AMENDMENT OF SOLICITATION/MODIFICATION OF CONTRACT			1. CONTRACT ID CODE	PAGE OF PAGES 1 4
2. AMENDMENT/MODIFICATION NO. 0002	3. EFFECTIVE DATE 11-Dec-2008	4. REQUISITION/PURCHASE REQ. NO.		5. PROJECT NO.(If applicable)

14. DESCRIPTION OF AMENDMENT/MODIFICATION (Organized by UCF section headings, including solicitation/contract subject matter where feasible.) The purpose of this amendment for solicitation W917PM-09-R-0011 is to answer questions from the offeror and to incorporate a site utility plan as an attachment.				
Except as provided herein, all terms and conditions of the document referenced in Item 9A or 10A, as heretofore changed, remains unchanged and in full force and effect.				
15A. NAME AND TITLE OF SIGNER (Type or print)		16A. NAME AND TITLE OF CONTRACTING OFFICER (Type or print)		
		TEL:	EMAIL:	
15B. CONTRACTOR/OFFEROR _____ (Signature of person authorized to sign)	15C. DATE SIGNED	16B. UNITED STATES OF AMERICA BY _____ (Signature of Contracting Officer)		16C. DATE SIGNED 11-Dec-2008

**Questions & Answers RFI # I
Kandahar TMC Solicitation
W917PM-09-R-0011**

TROOP MEDICAL CLINIC
Kandahar, Helmund Province Afghanistan

SHEET REFERENCE NUMBER:
A - 2

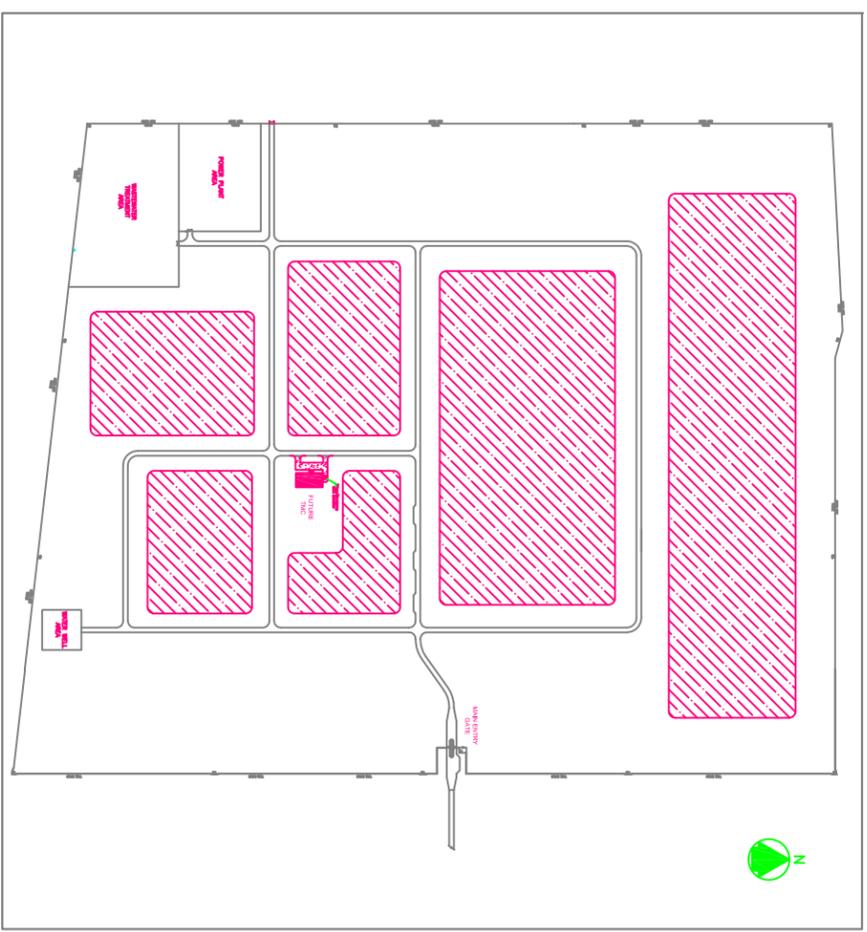
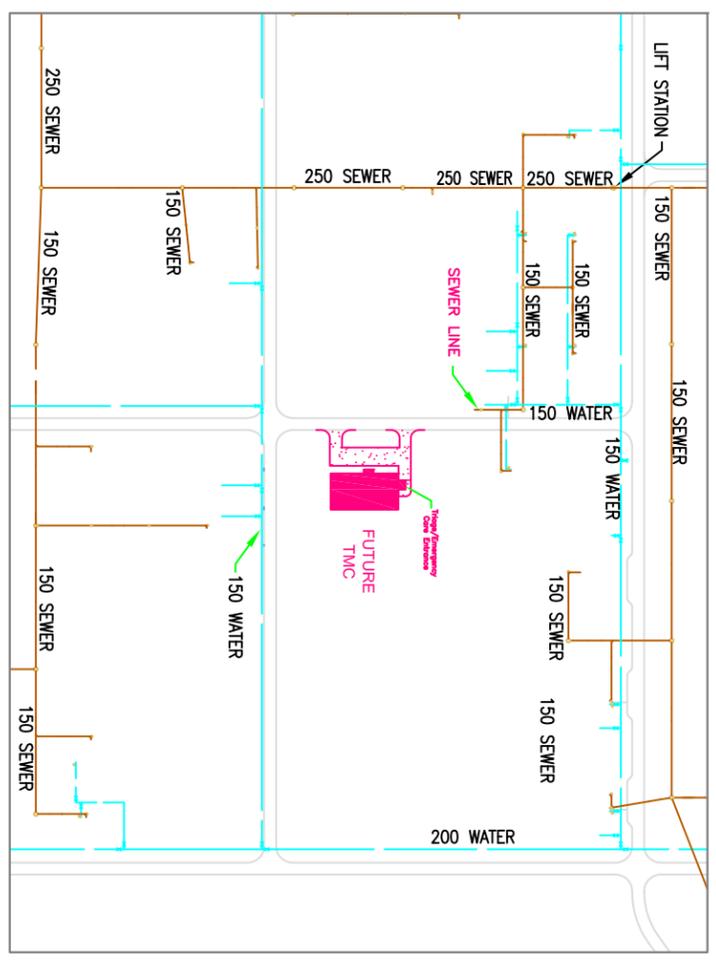
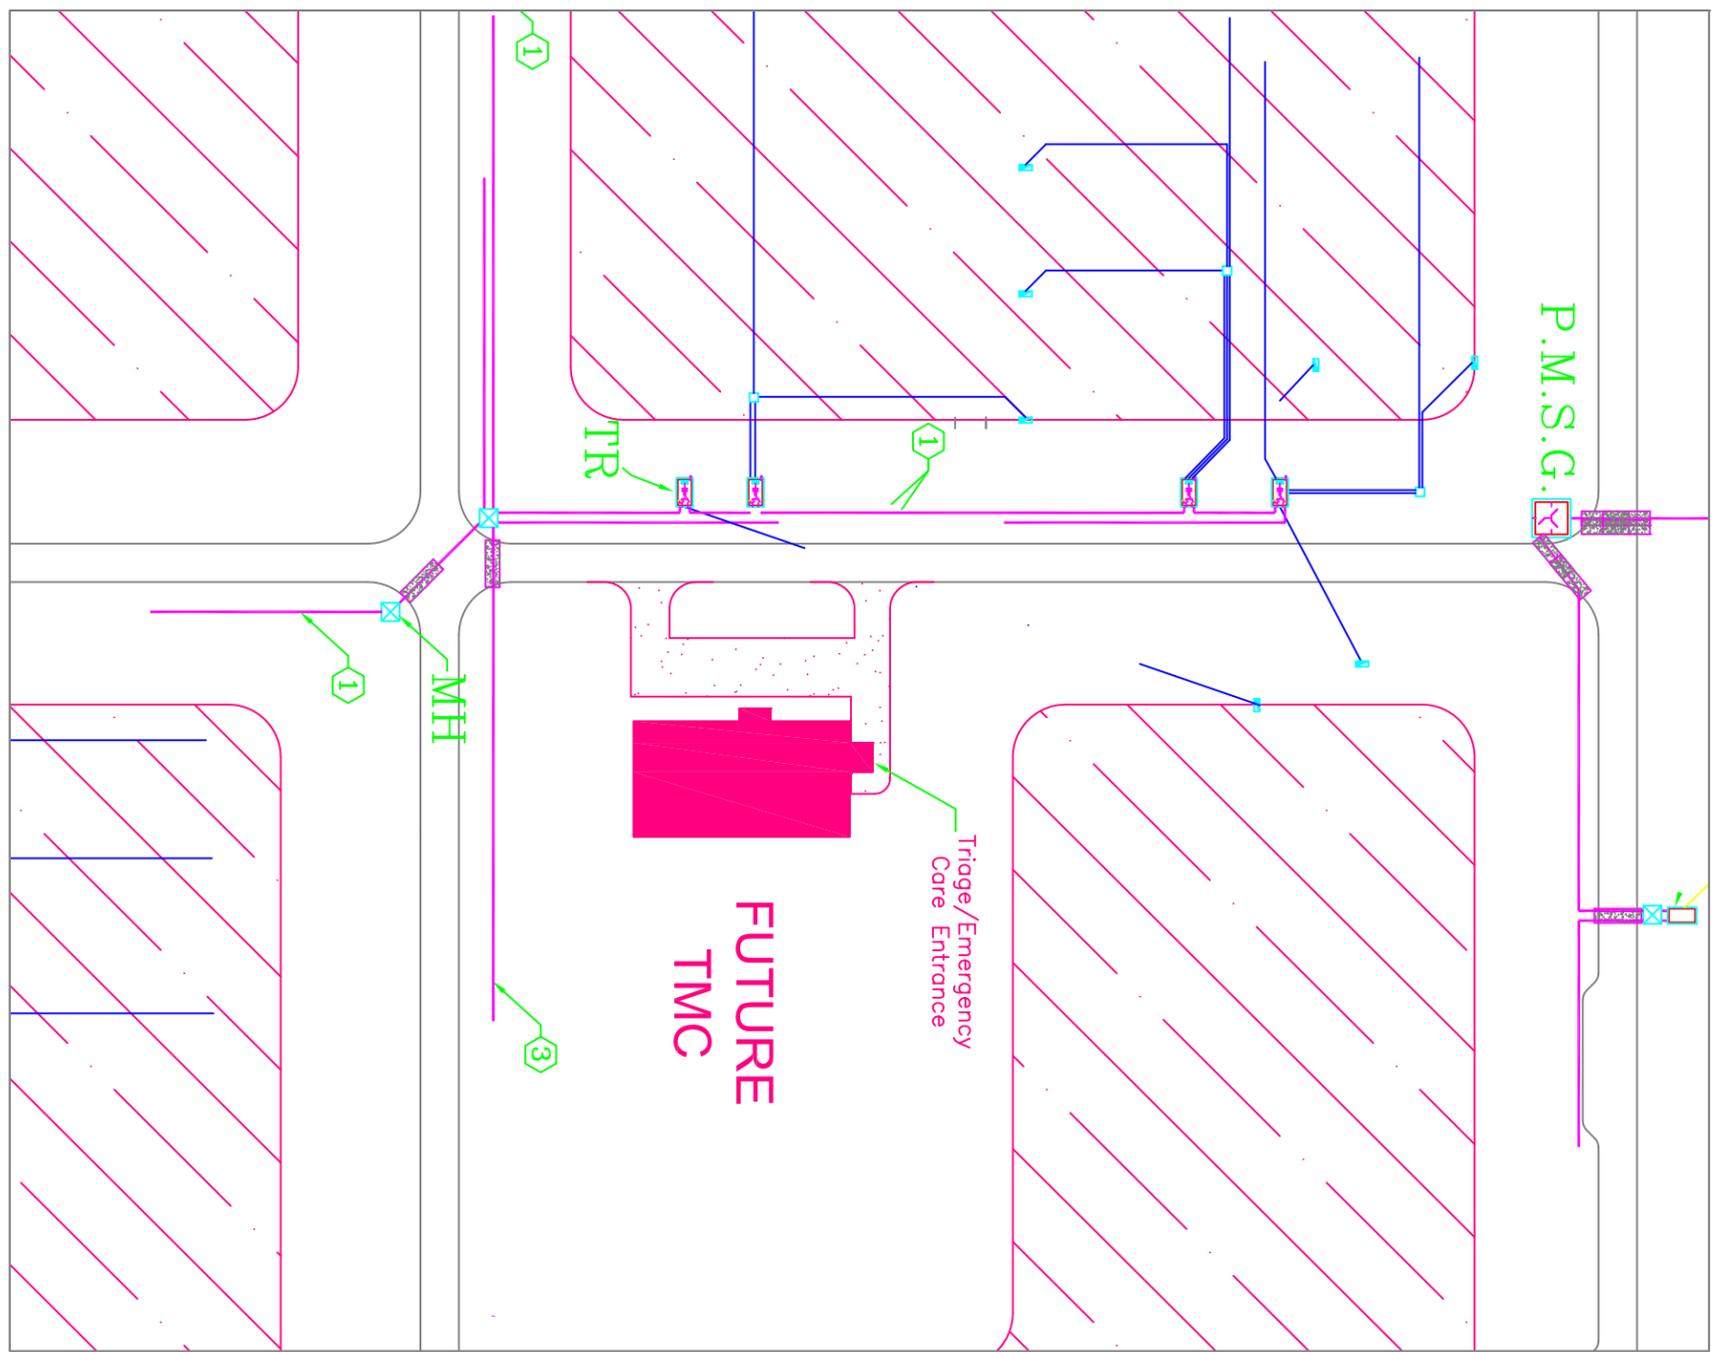
Q.5. Shall the water needed for the TMC be connected to the existing well house or the existing water network and the pressure adjusted at the TMC to prevent water hammer.

Q.8. What are the dimensions and distances for the vehicle parking, roadway, and sidewalks?

Q.13. Will existing utility drawings be provided?

A.5. Connect to the existing water network. Attachment A-2 shows location of the buried electric, sewer, and water lines in proximity to the TMC site. Contractor shall design the system to achieve needed water pressure within the building while preventing water hammer.

A.8. This is a design-build contract. The contractor is expected to design and construct the questioned dimensions according to the SOW, Technical Specifications, and International Standards listed in the solicitation. The approximate net dimension of the concept drawing is 135ft x 72ft (41m x 22m). The winning contractor will be required to master plan the best location of the TMC in the general immediate area illustrated on drawing Sheet A-2. Additionally, a sidewalk surrounding the building and parking for 8 vehicles is required, with the building and parking space sited close to the street as illustrated on drawing Sheet A-2.

A.13. Existing utility drawings will be given to the winning bidder after award of contract. For the purpose of bid preparation, the contractor shall include the cost of increased power capacity as an option item (see Line Item 0006 of Section 00010) in the cost proposal. Additionally, drawing sheet A-2 (included in this amendment) provides information regarding location of the TMC site in comparison to the WWTP and Power Plant.
